## North Westerly - PD zoning 4th Review

To: John Prestwich, PCS Group  
From: Aly Burkhalter, Senior Planner  
Date: March 13, 2025  
Re: PD-001700-2024 North Westerly - PD

#### 4<sup>th</sup> Review & Referral Comments

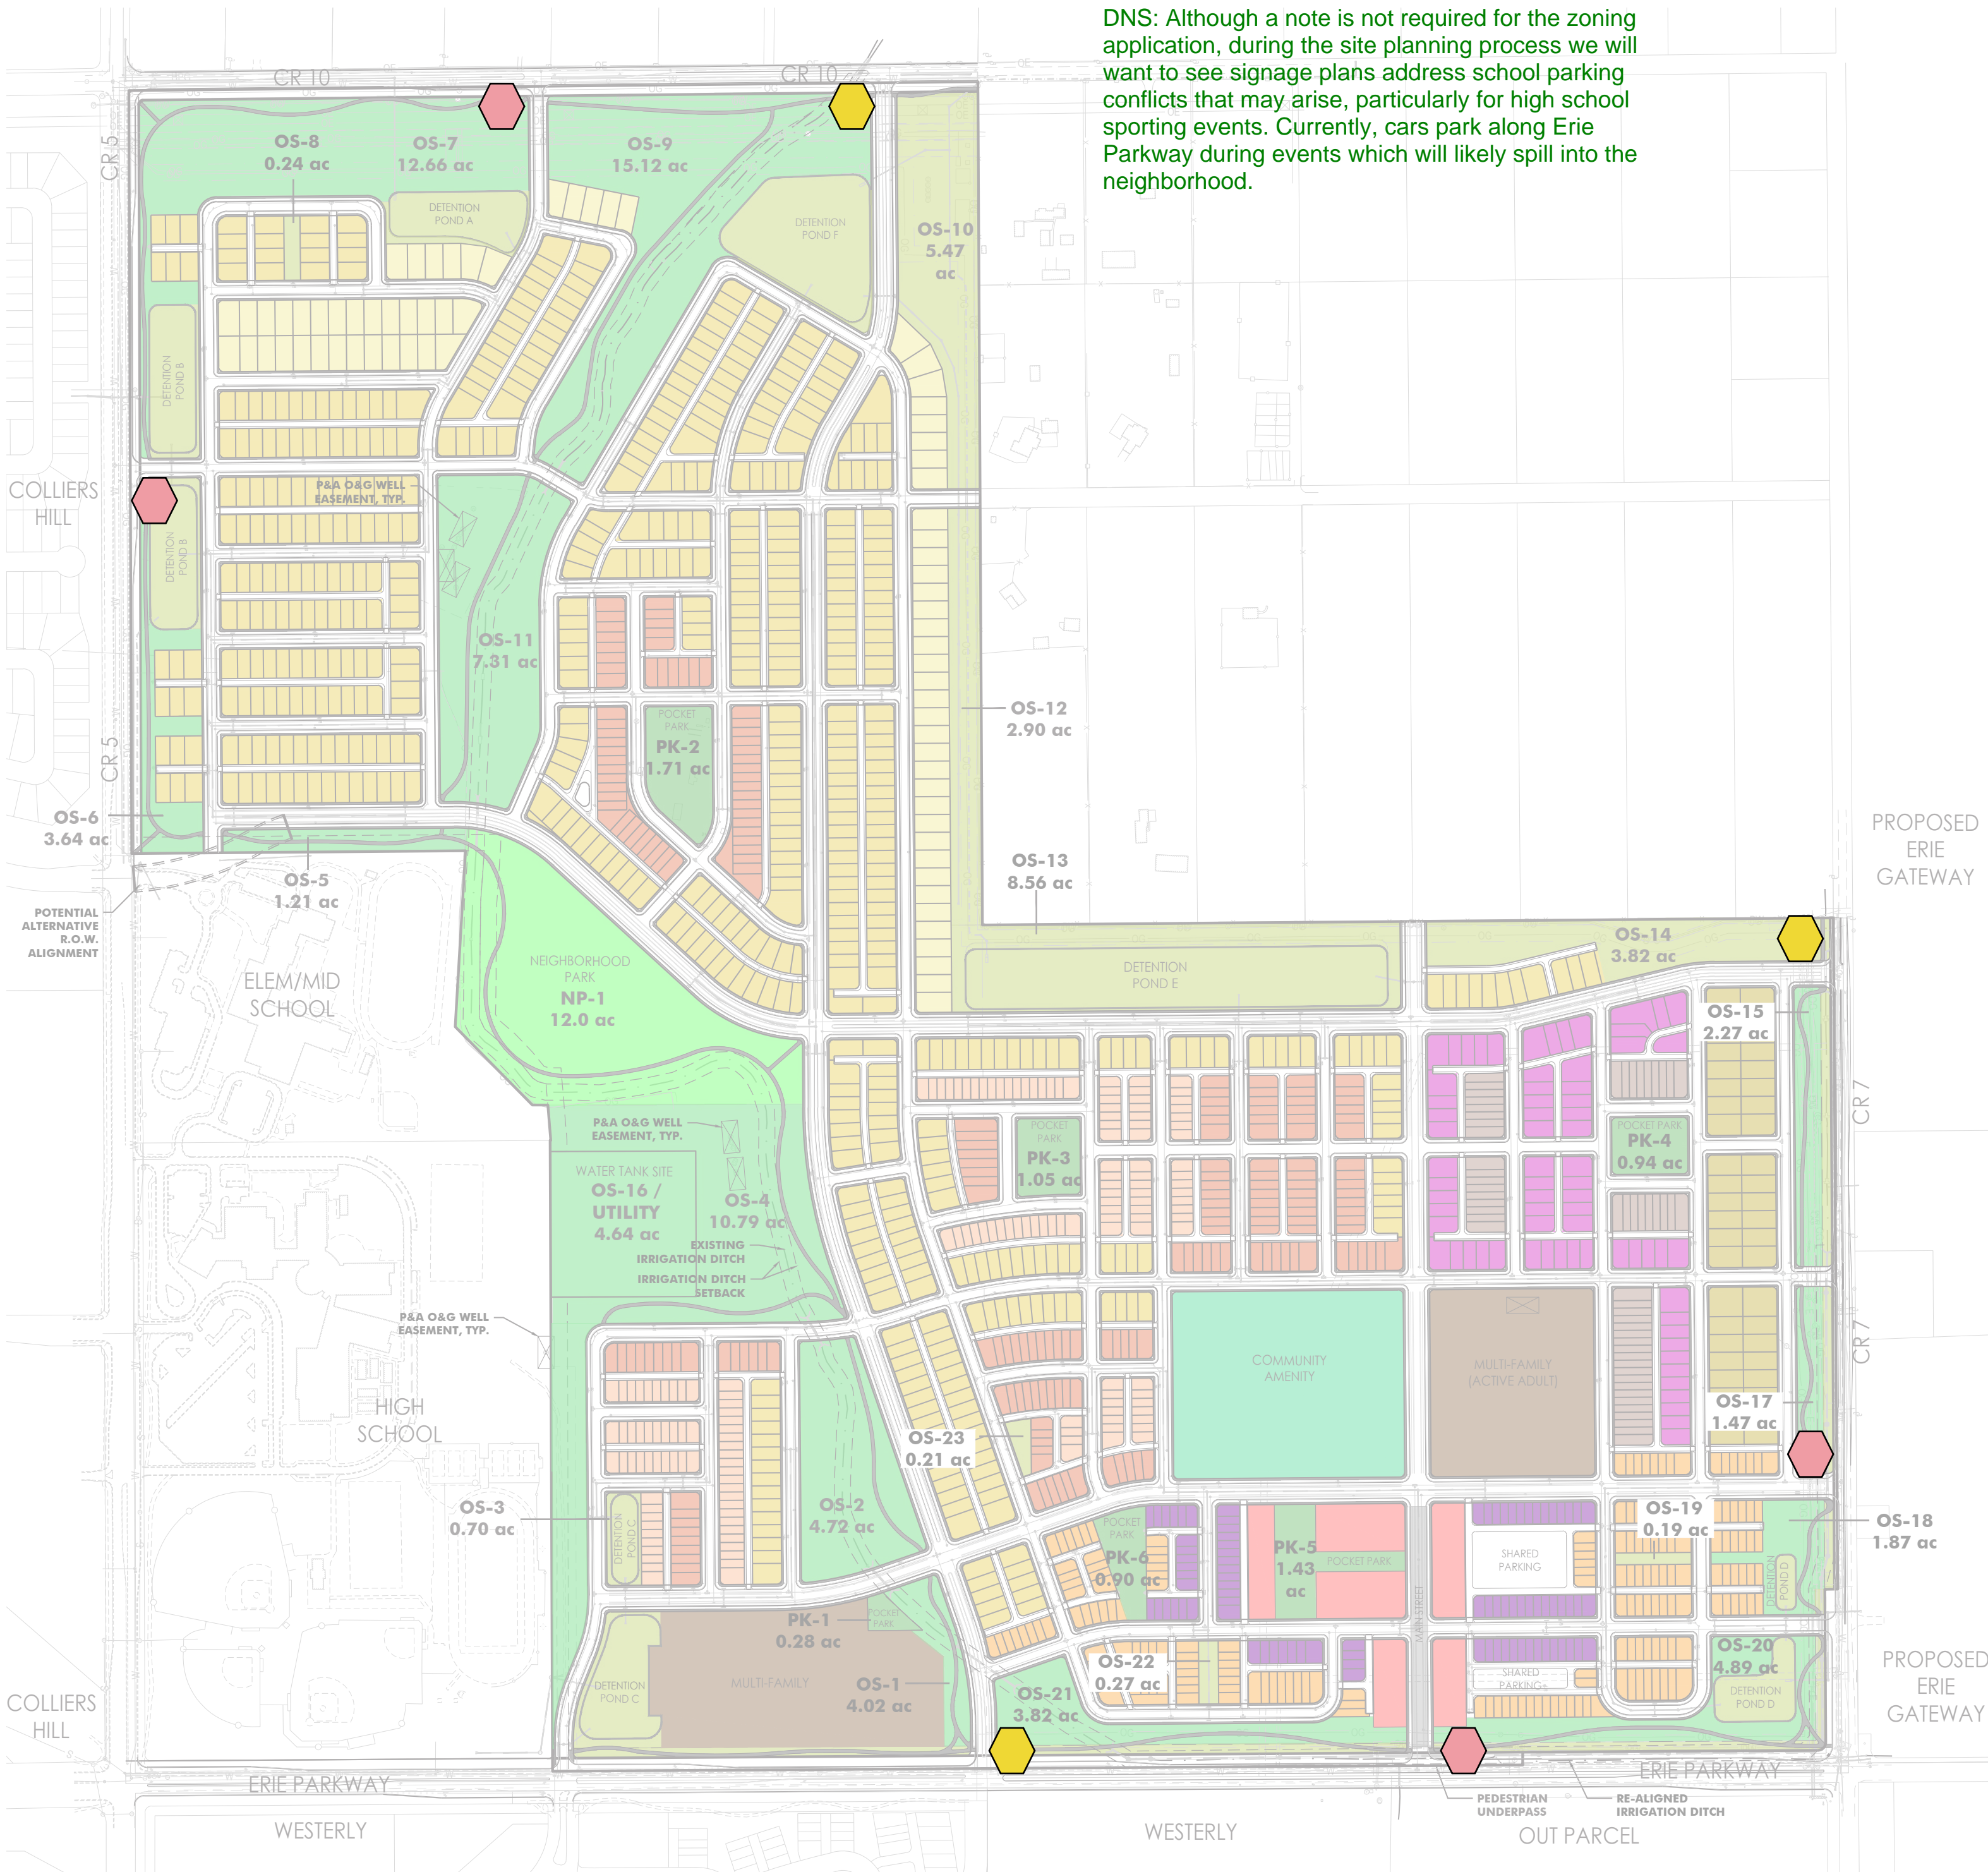
126. [Sheet 17 Signage Plan] Please provide a key map of planned Monument Signs. Per UDC, only one monument sign per street frontage is allowed for each development. If multiple monument signs are desired along Erie Parkway, a monument sign plan shall be provided in the PD Development Guide. Applicant 3<sup>rd</sup> submittal response: Created a key map with the monument signs. Town 3<sup>rd</sup> review response: Upon review of the monument sign key map per UDC 10-6-12.H.3 "Monument signs located along Erie Parkway shall not be located in an easement or a landscaped tract." Please add note to sheet that monument signs shall not be located in landscape tracts or within easements without permission of easement holder.

## OVERALL LIGHTING PLAN

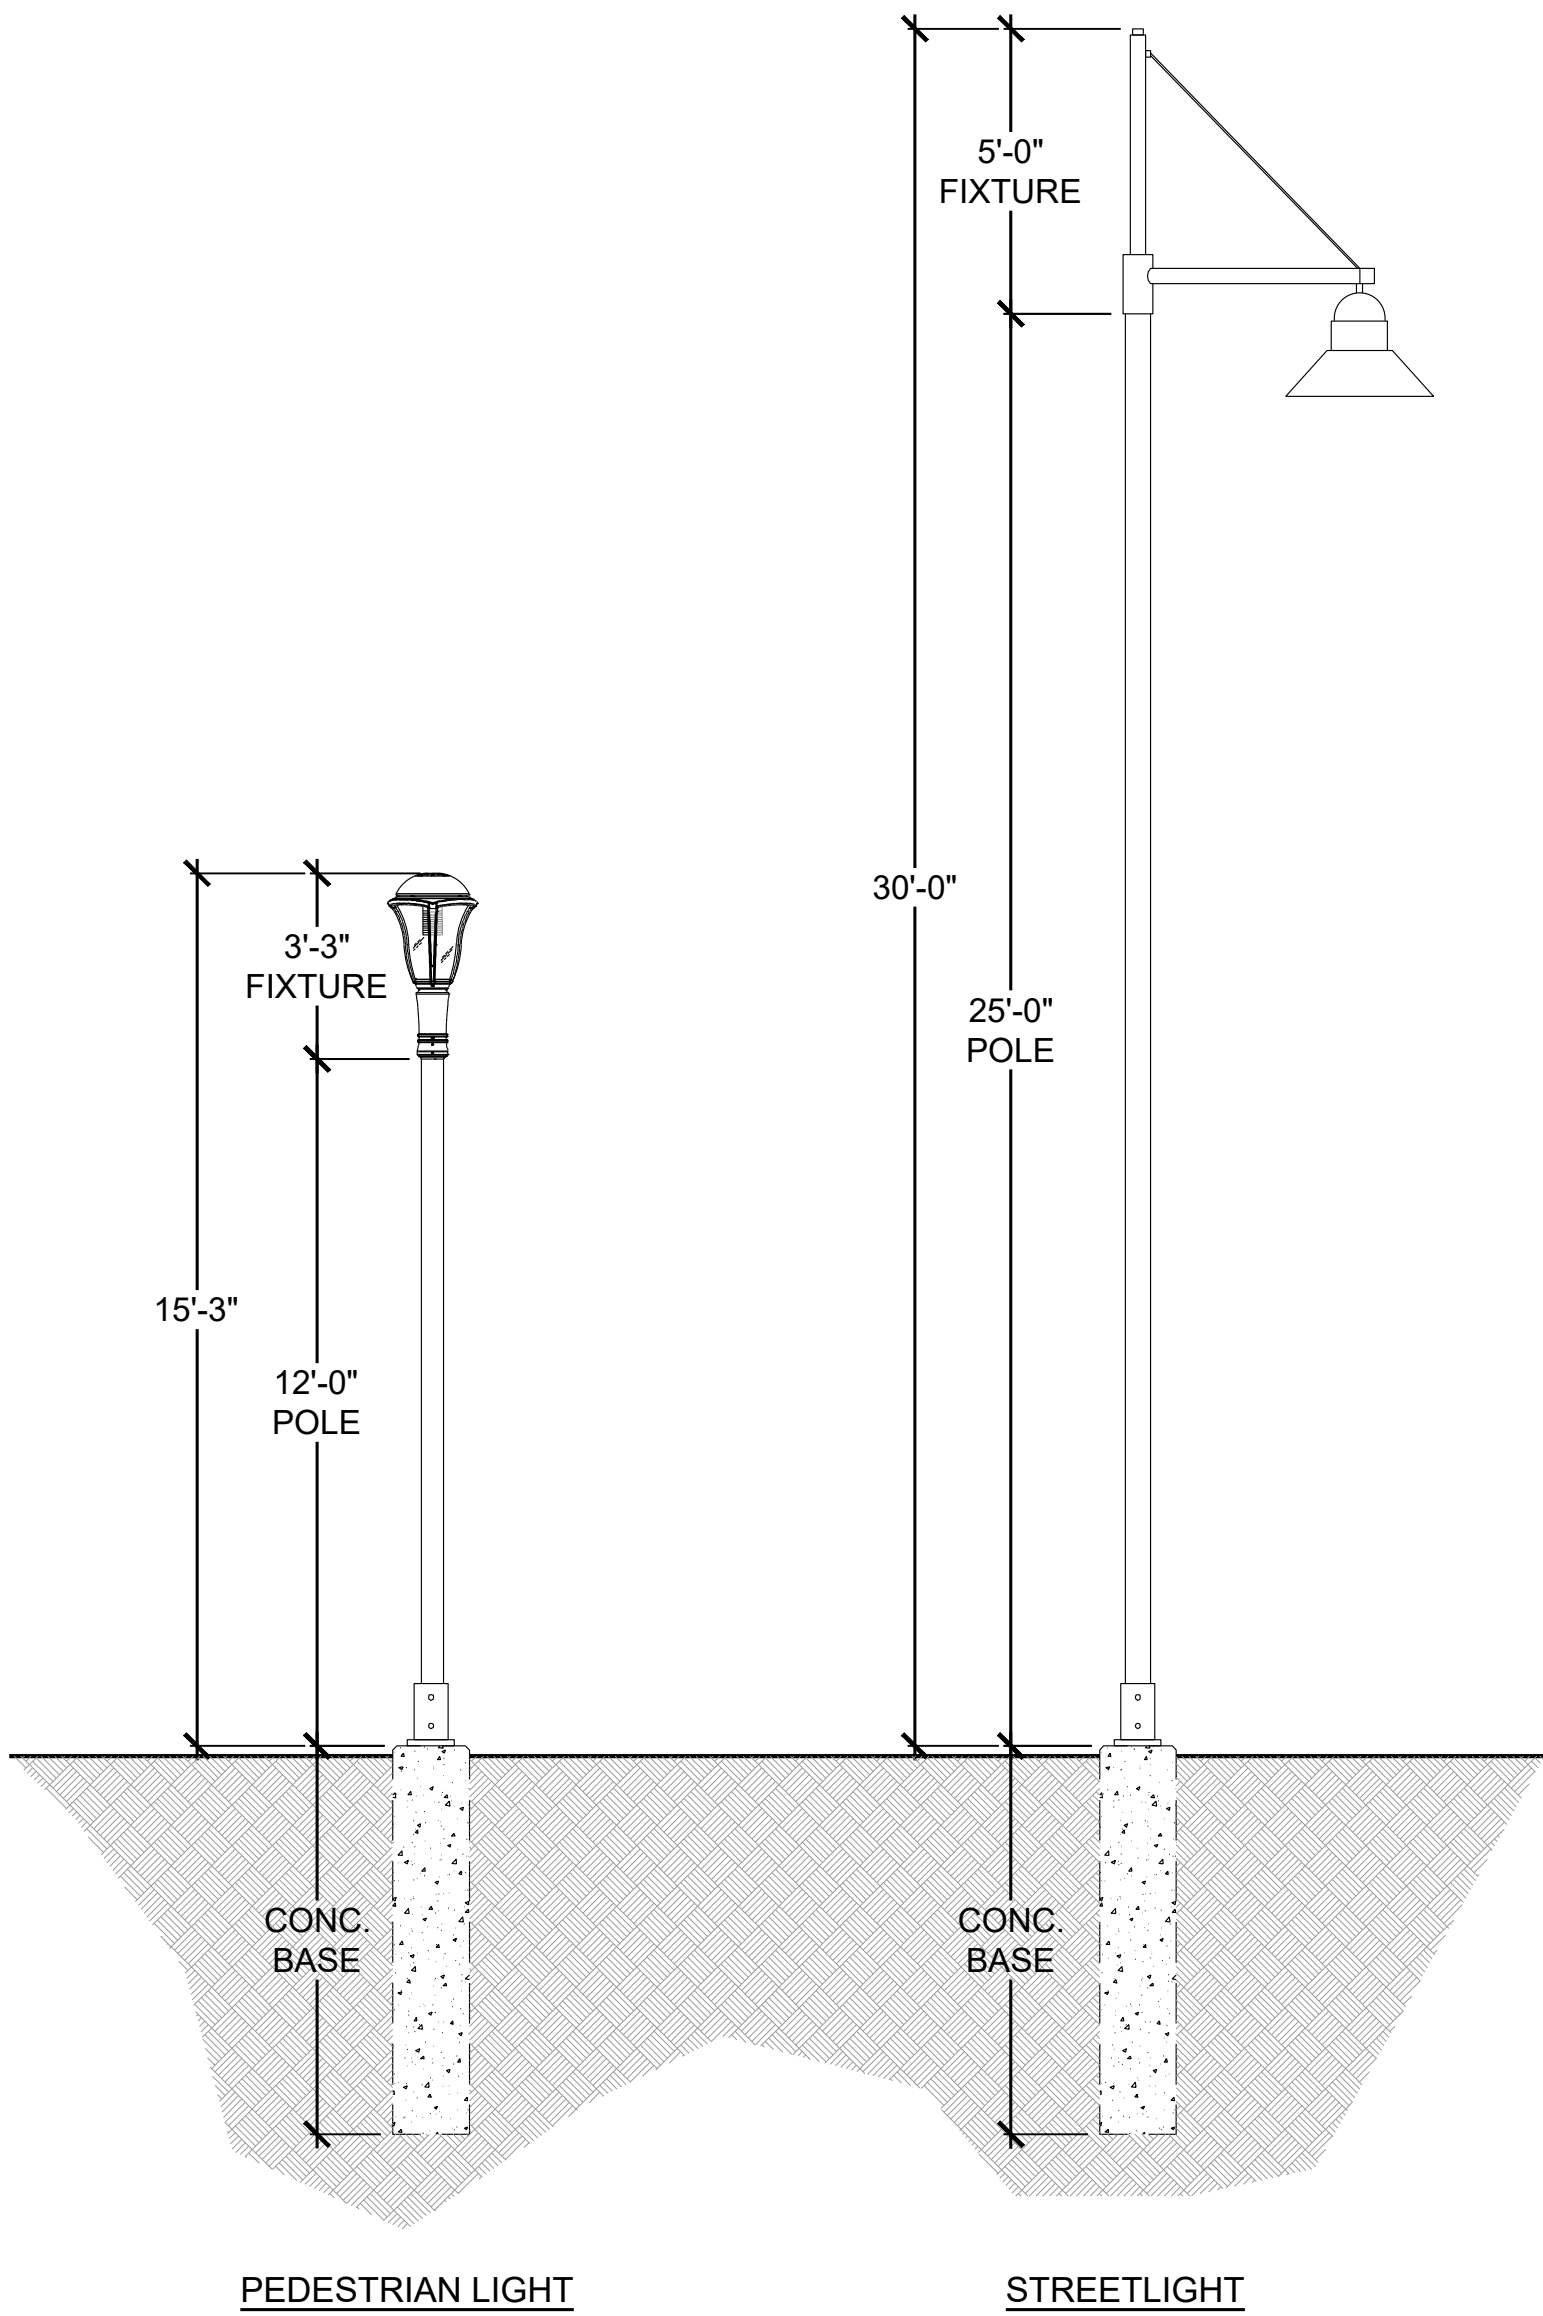
128. [Sheet 17 Overall Lighting Plan] If you are using the same fixtures of the existing Westerly neighborhood. Please provide a scaled fixture design with height label.  
Applicant 3<sup>rd</sup> submittal response: We have added the fixture with the height labeled.  
Town 3<sup>rd</sup> review response: Resolved
